Title <b>BSC ISI System Wiring</b>			
Size: <b>B</b>	DCC Number: LIGO-D0901301		<i>Ligo Project</i> <i>California Institute of Technology</i> <i>Massachusetts Institute of Technology</i> 
Drawn by: Ben Abbott	Date: 6/25/2009	Revision: v1	
File: C:\Ben\Seismic\ISI\BSC_ISI\BSC_ISI_7.SchDoc			Time: 9:49:37 AM Sheet 7 of 7

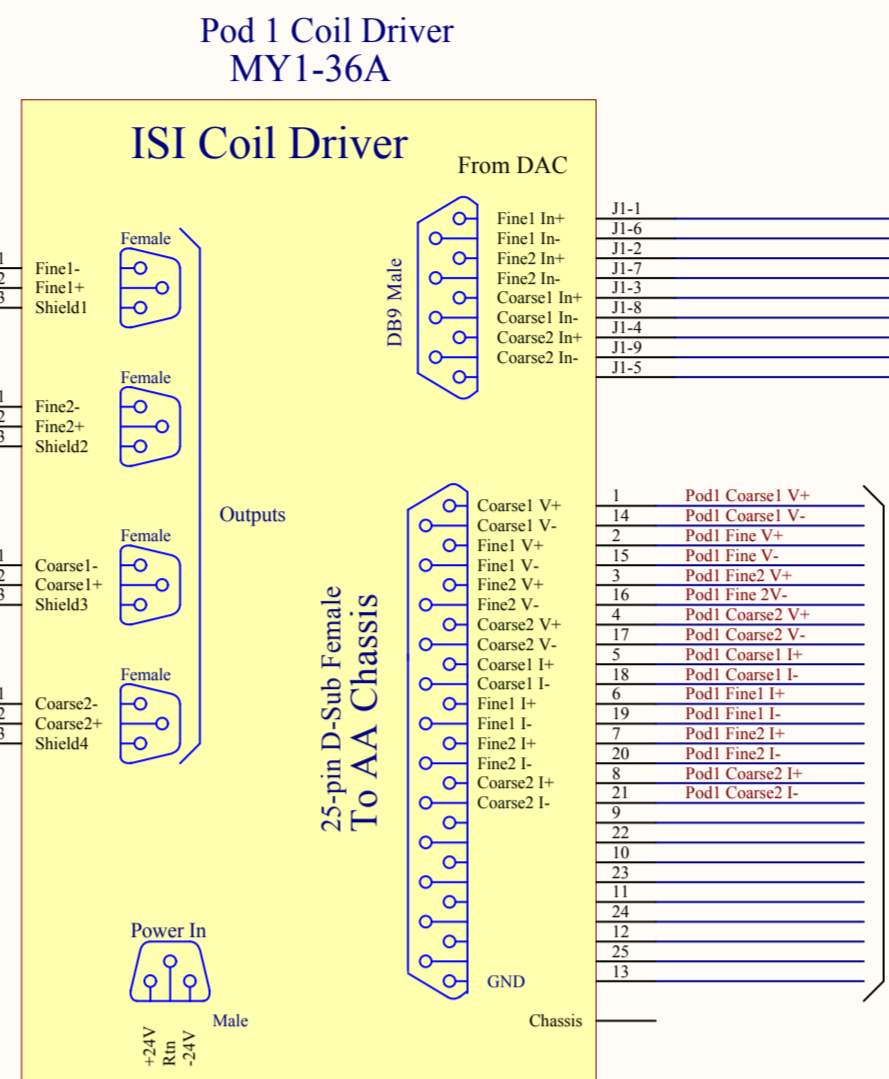
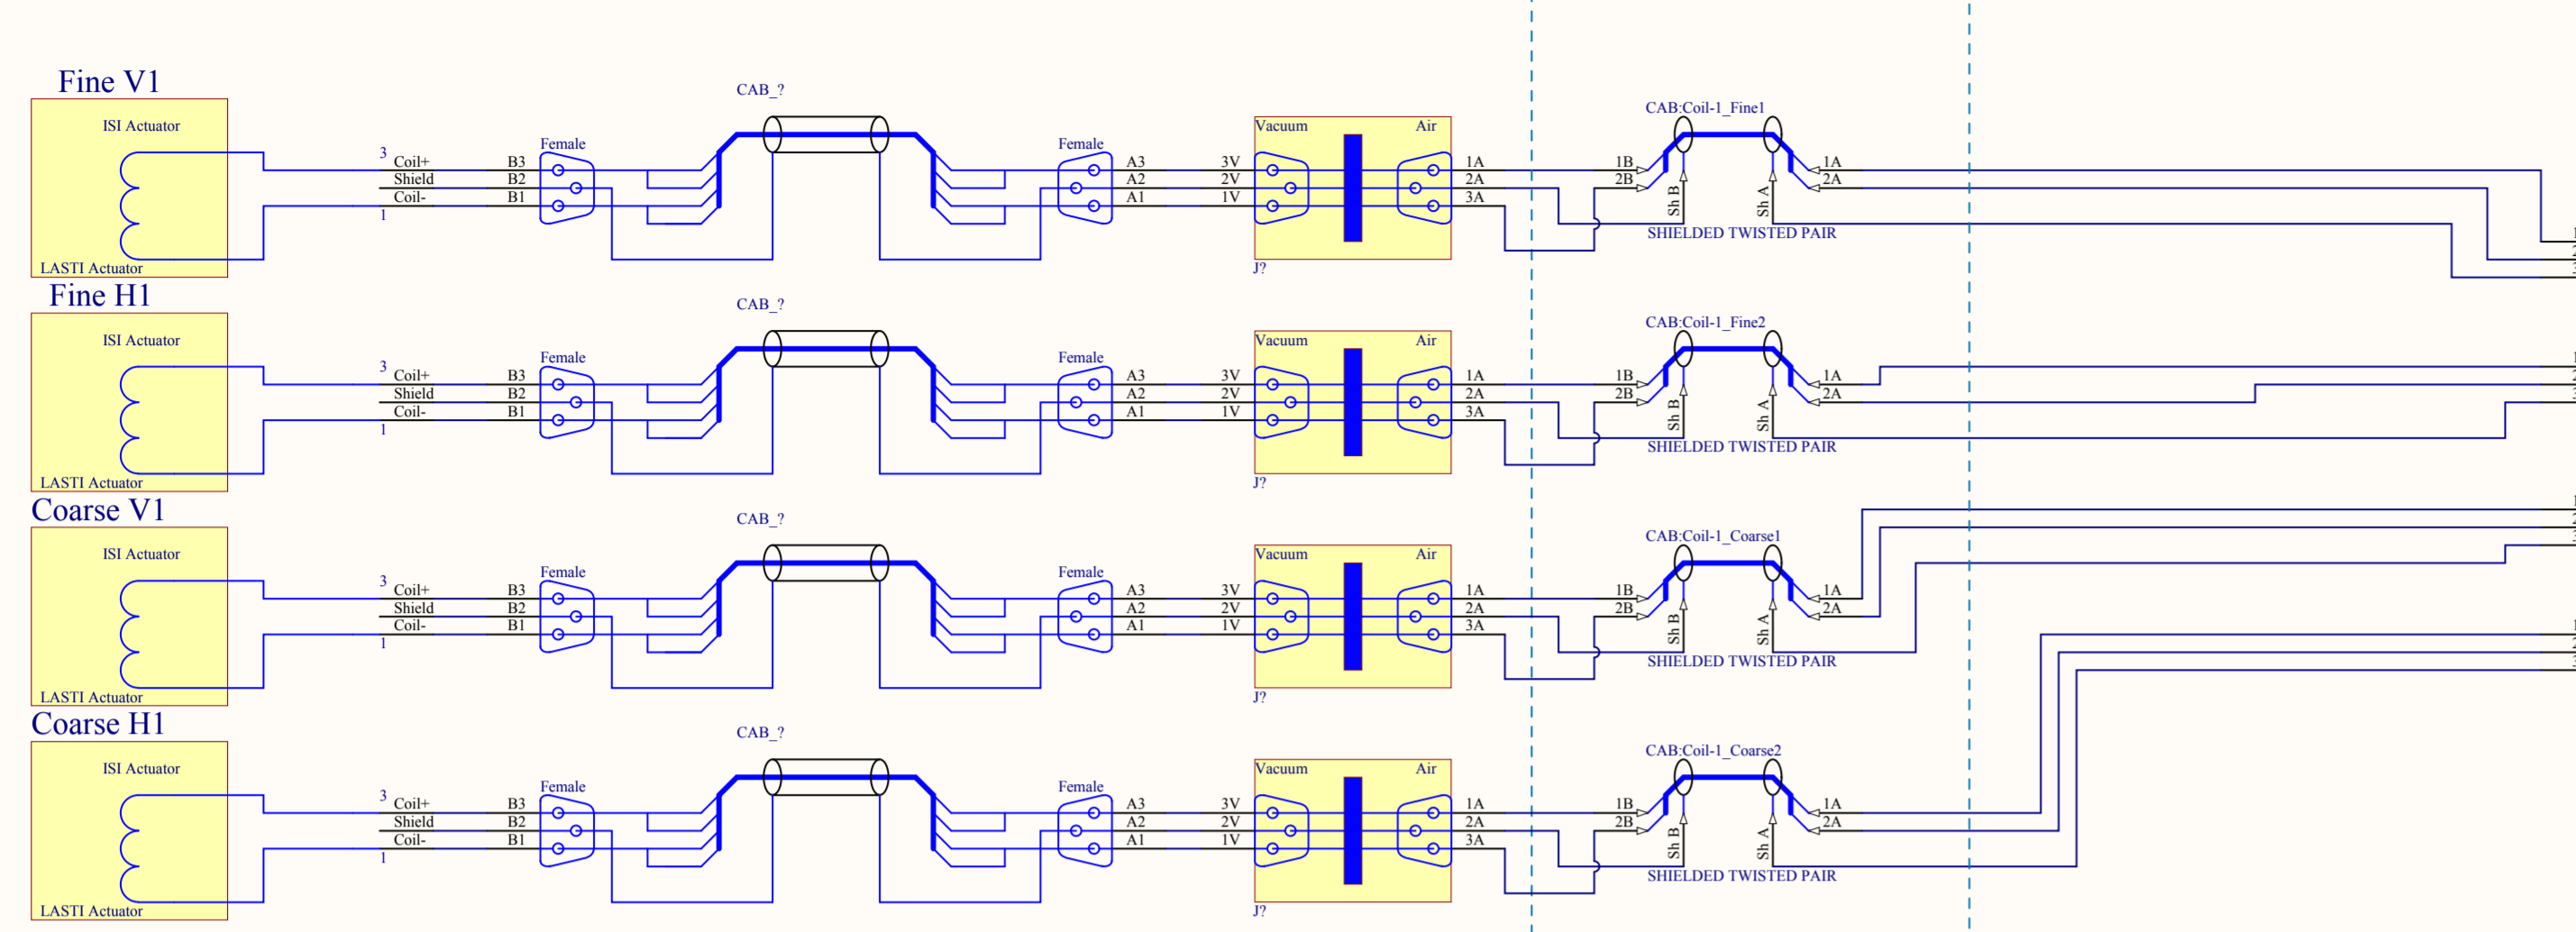
These cables currently have a pin flip and need to be fixed.

3 ← 1  
1 ← 2  
2 ← 3

This is their current pinning.

To ADC Interface MY1-10 Sheet 4

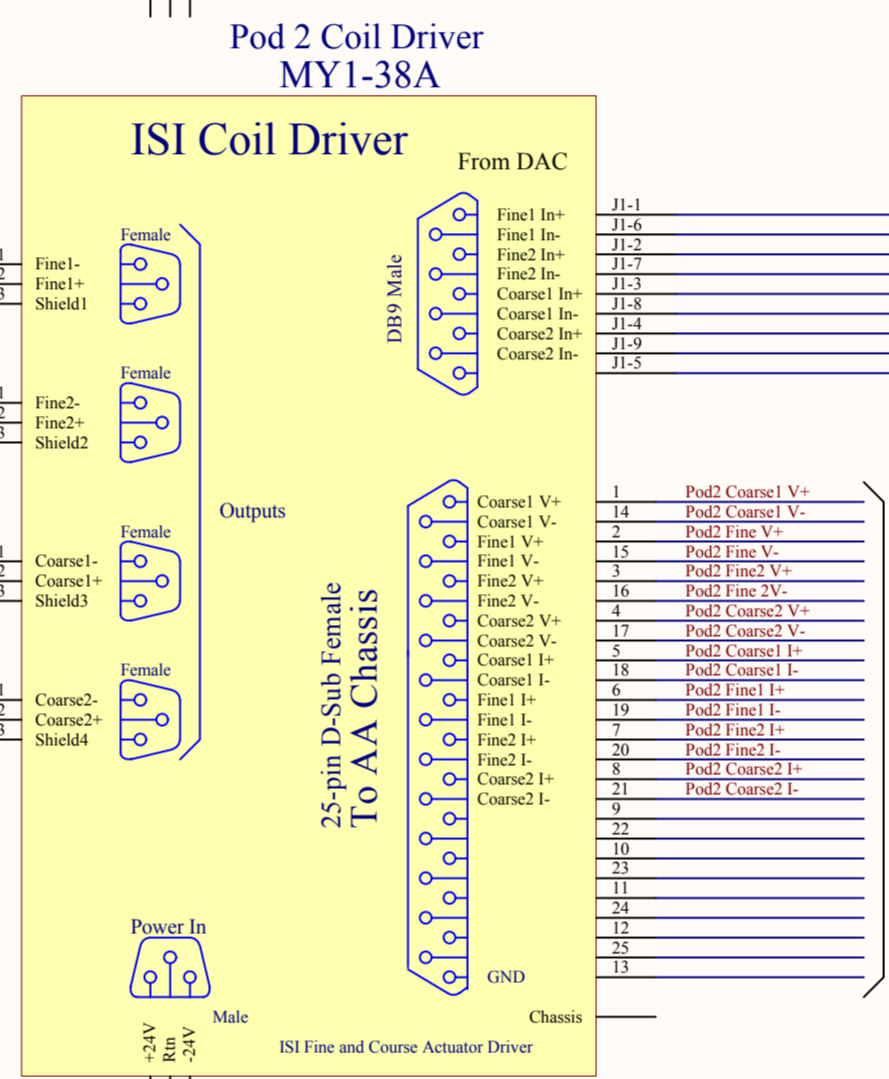
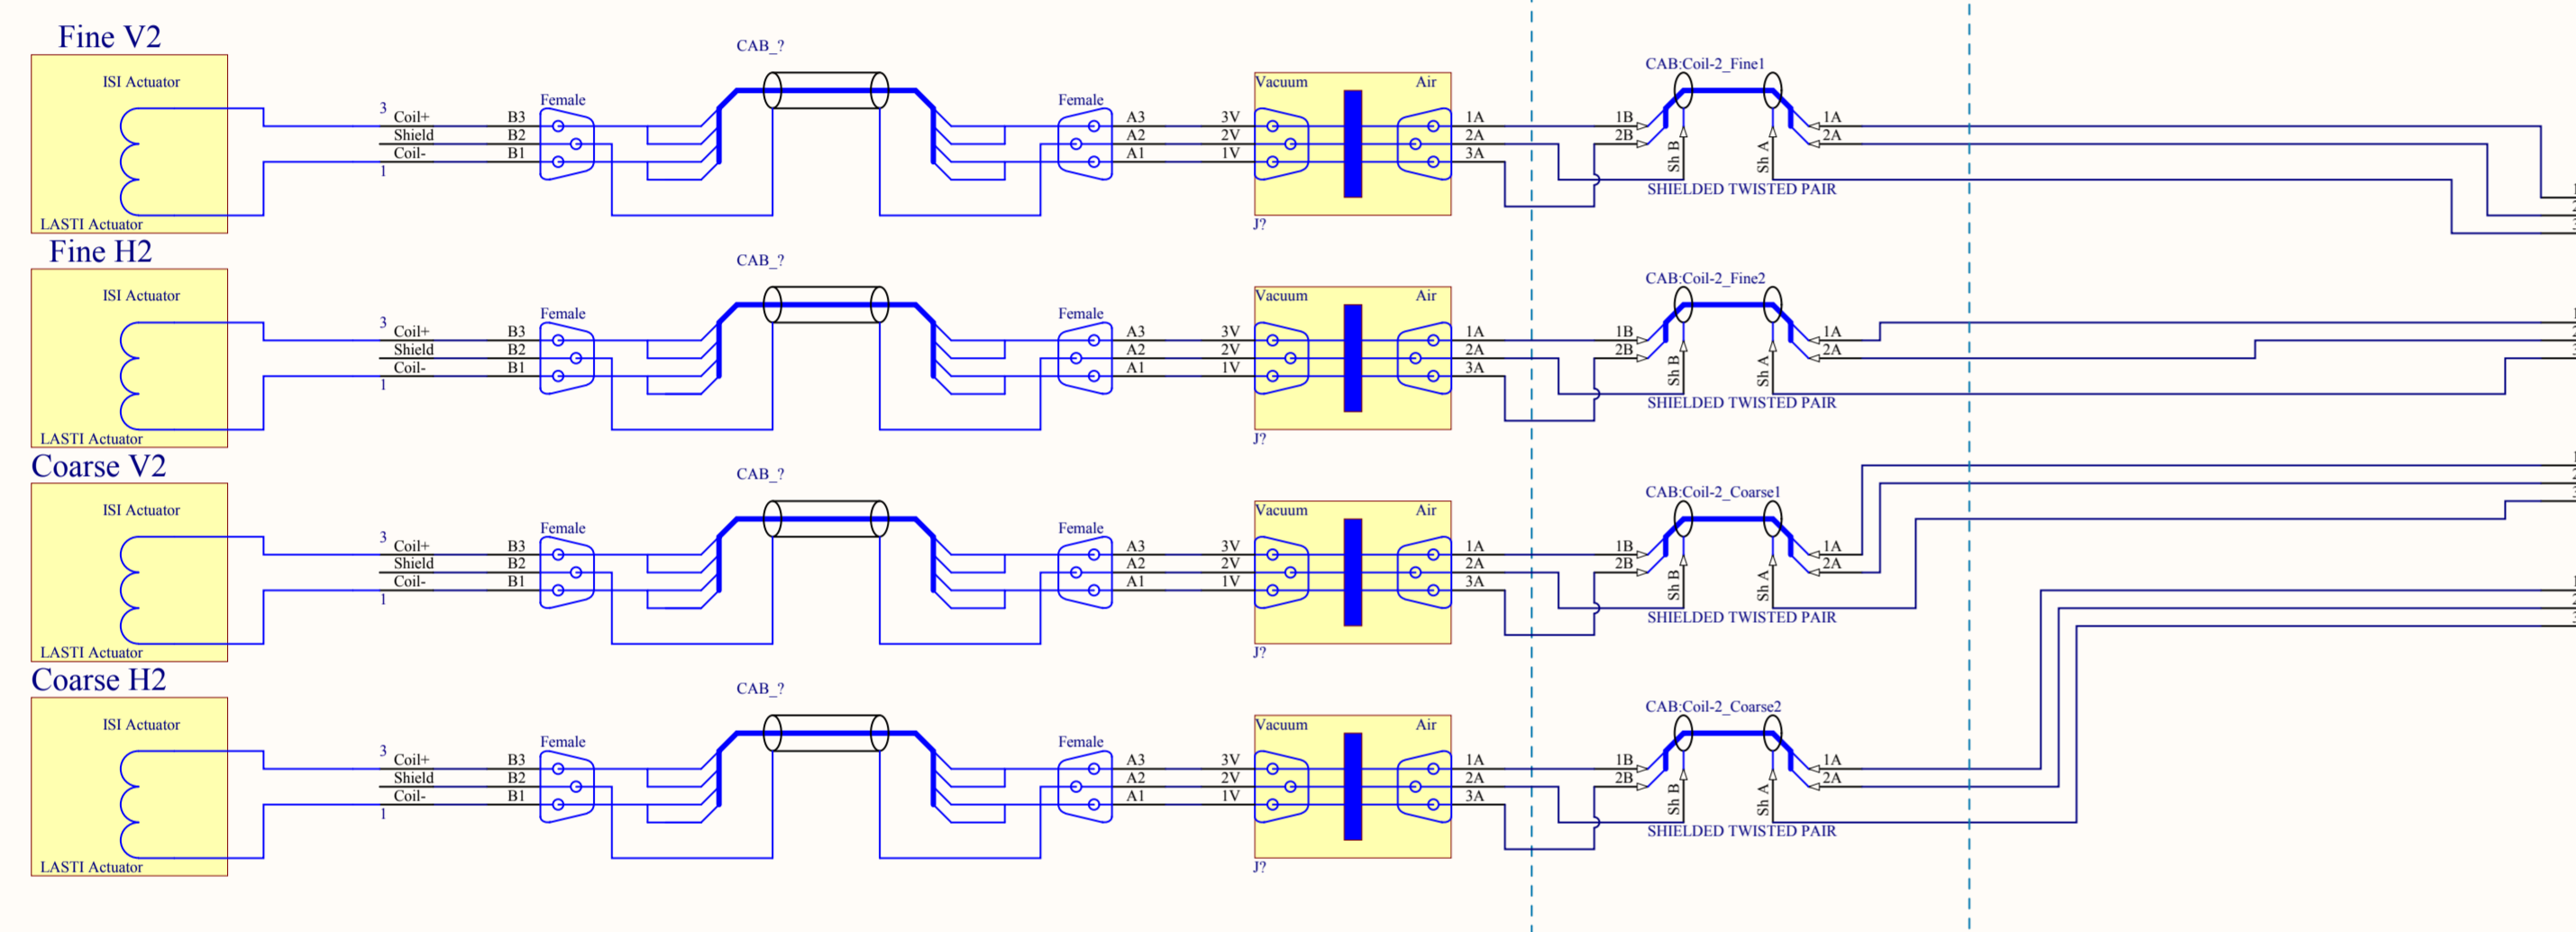
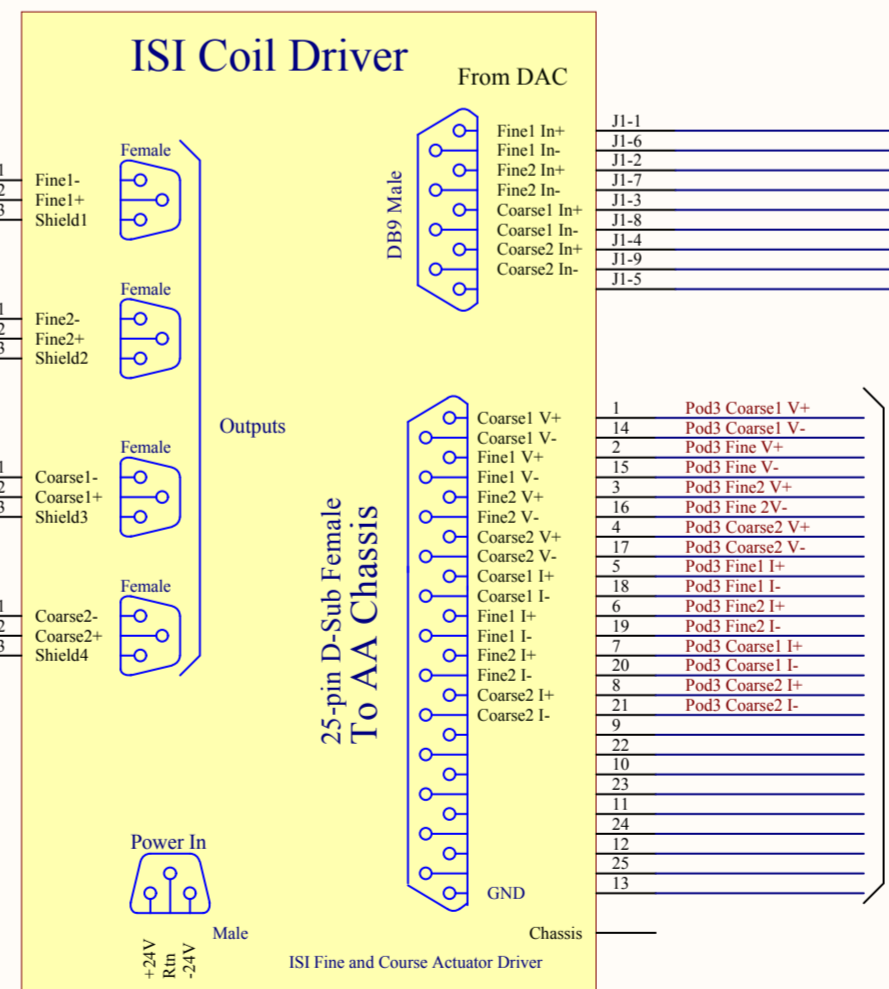
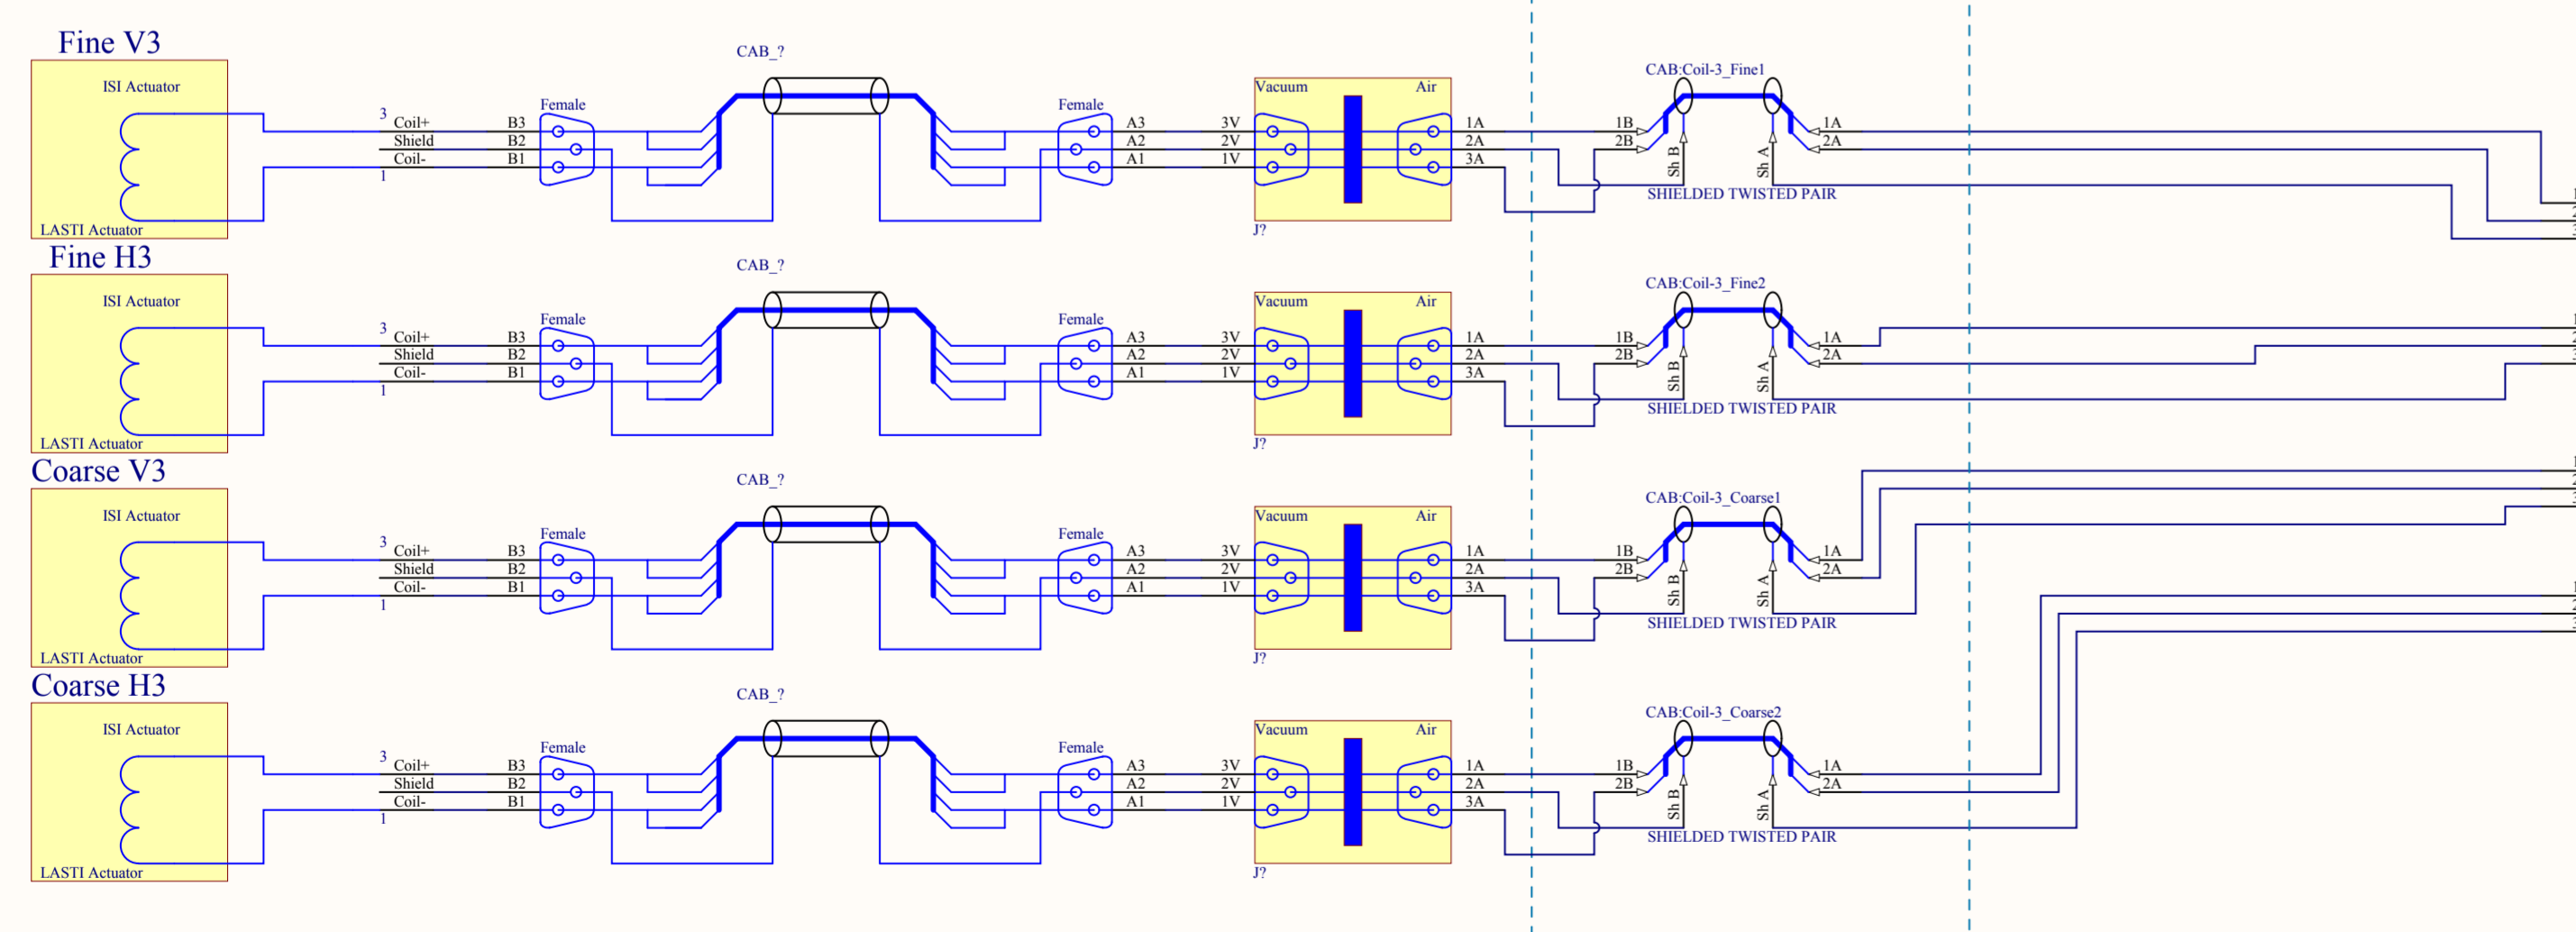
Cables shown below are how they should be.
